TOWN OF MILFORD

Michael Dean, P.E.
Town Engineer

September 28, 2020

Re: **"The Residences at Stone Ridge – Phase II"**
Application for Comprehensive Permit (40B)

Exhibit “A”

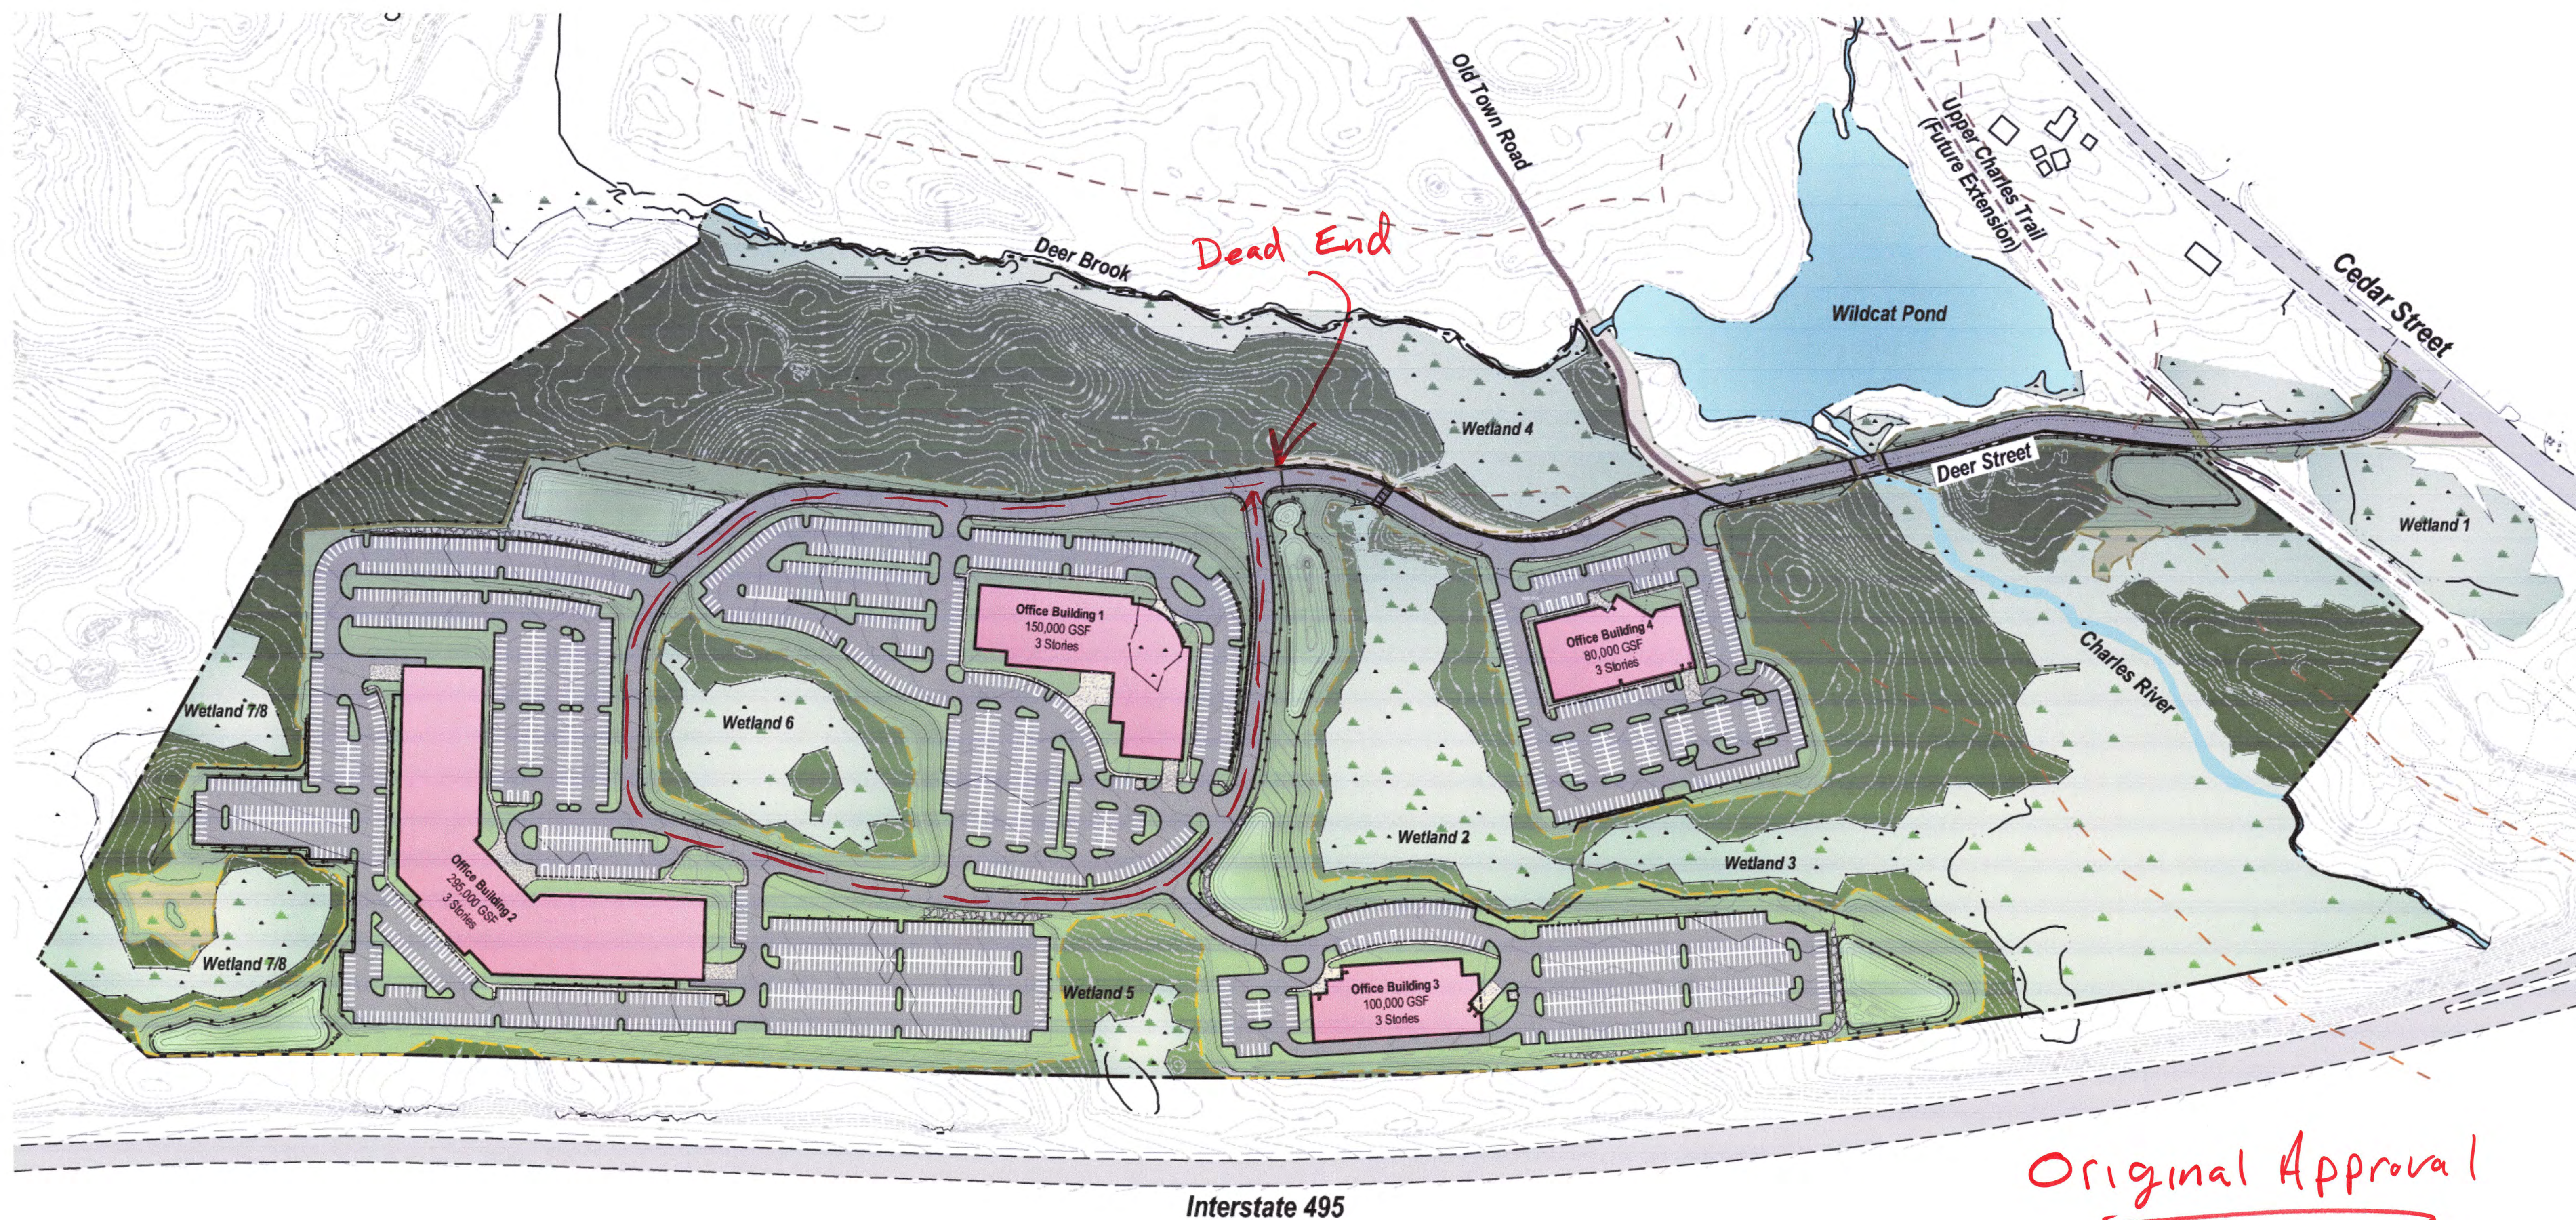
3. Sections of the proposed drives are designed at almost 10% slopes; this may pose some additional safety issues for fire apparatus. The original approvals showed the main Looped Drive at or around only 5% slopes (see Exhibits). Profiles of the proposed drive should be submitted. The scale indicated on the plans are not accurate.
